HARTZELL PROPELLER INC.
SERVICE LETTER
TRANSMITTAL SHEET
HC-SL-61-61Y

**Propeller - Overhaul Periods and Service Life Limits for
Hartzell Propeller Inc. Aviation Components -
Propellers, Governors, Accumulators, and Propeller Damper Assemblies**

This page transmits a revision to Service Letter HC-SL-61-61Y.

Revision 13 is issued to change the following:

**Aluminum Hub Propellers on Turbine Engines Identification - Raptor Series
Figure 8**

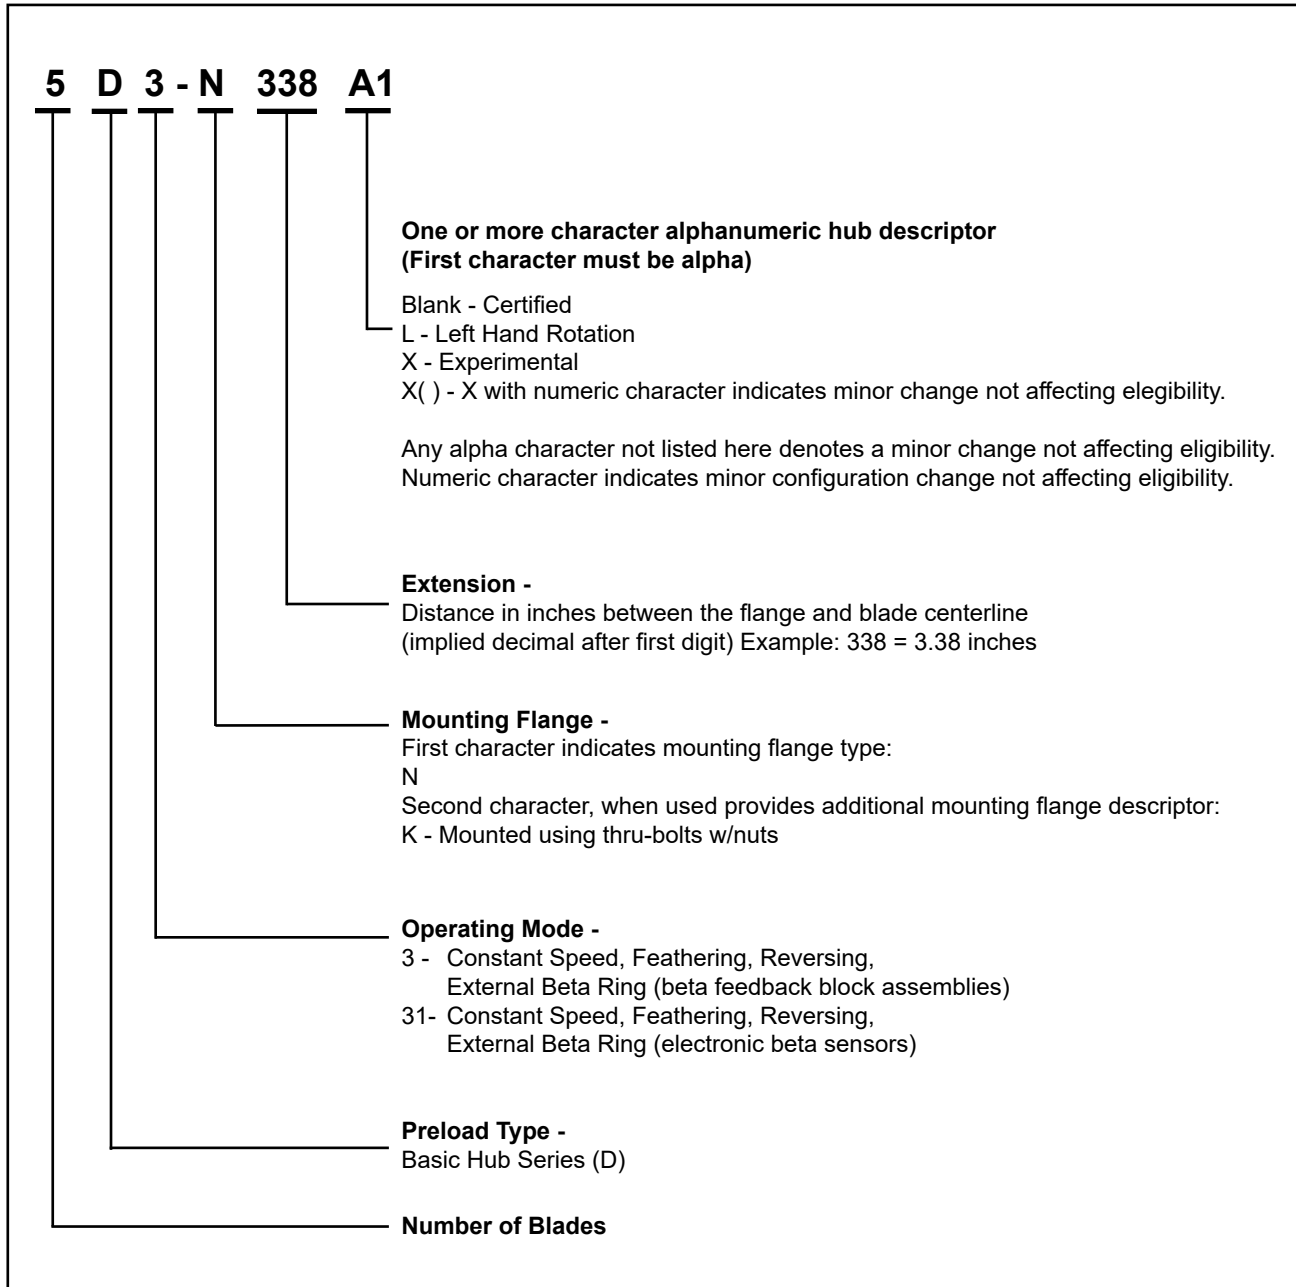
- Revised Table 5, "Overhaul Periods for Aluminum Hub Propellers on Reciprocating Engines - Raptor Series"
- Revised Figure 8, "Aluminum Hub Propellers on Turbine Engines Identification - Raptor Series"
